TRANS/WP.29/2004/63
20 July 2004

DRAFT 04 SERIES OF AMENDMENTS TO REGULATION No.44
(Child restraint systems)

Transmitted by the Working Party on Passive Safety (GRSP)

Annex 2

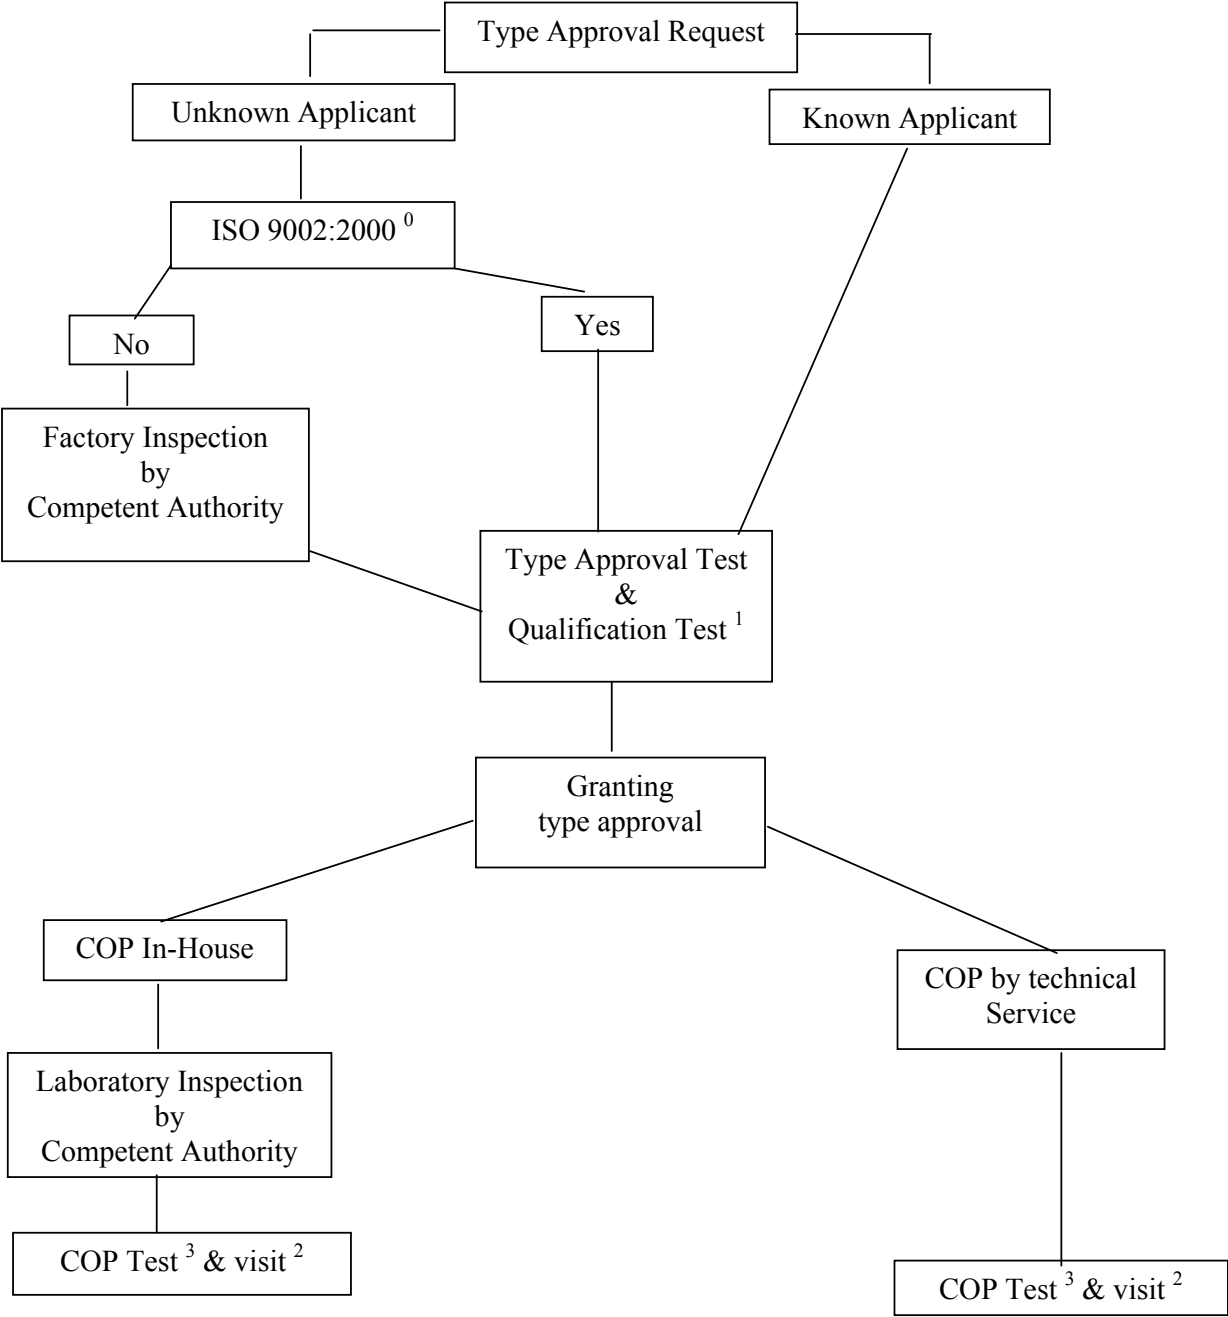
Figures of the approval mark, replace "032439" by "042439" and "032450" by "042450".

Text under the approval marks, replace "032439" by "042439", "032450" by "042450" and "03 series of amendments" by "04 series of amendments" (twice).
